## **Engineering Comments provided by Ayres Associates**

**RE: Preliminary Drainage Analysis  
Ruger Subdivision  
Part of Gov't Lot 3  
section 5, Township 3 North  
Range 75 West of the 6<sup>th</sup> PM  
2N Project No. 26003**

# RUGER SUBDIVISION

## TYPICAL CULVERT CALCULATION

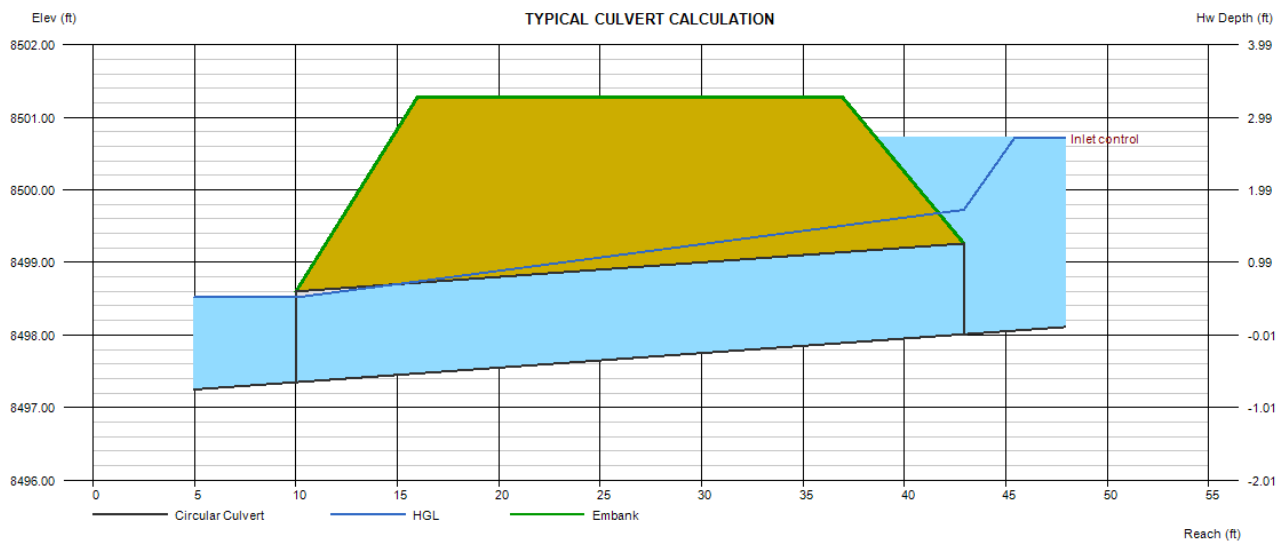
driveway culverts should be called out on the plat as required for proper drainage, 15" CMP

**EXISTING DRAINAGE MAP**

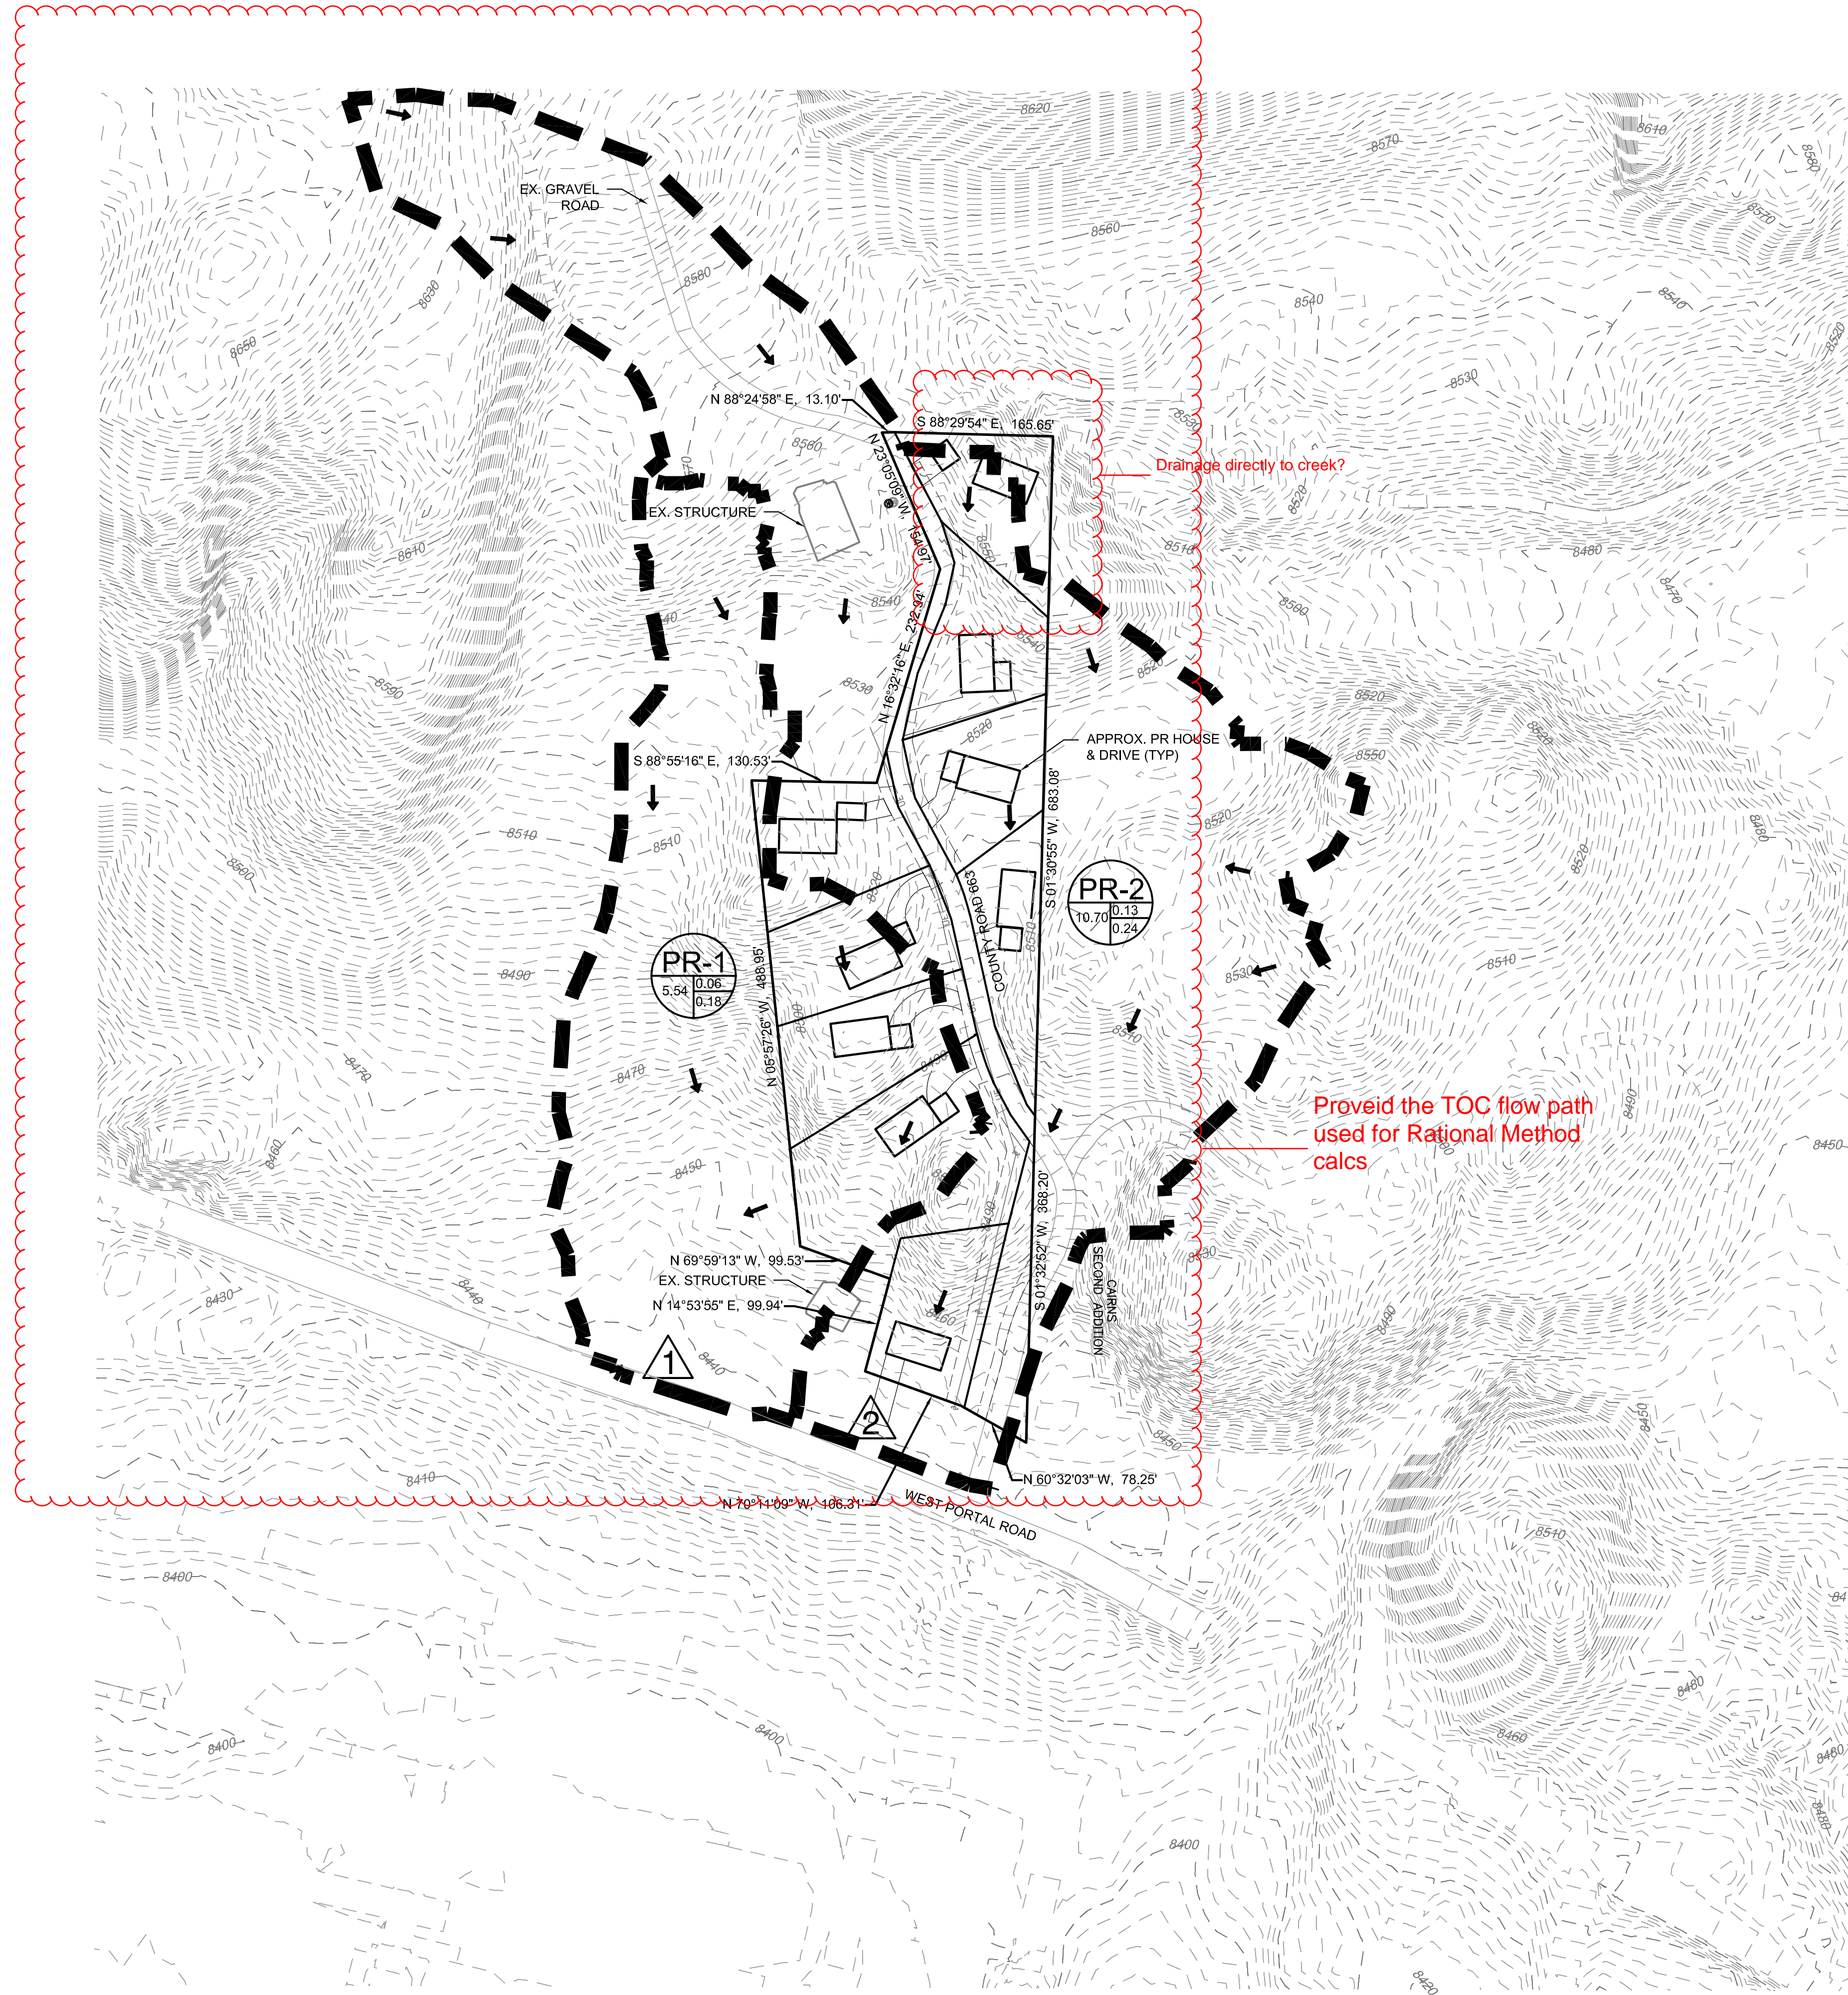
Provide the TOC flow path used for Rational Method calcs
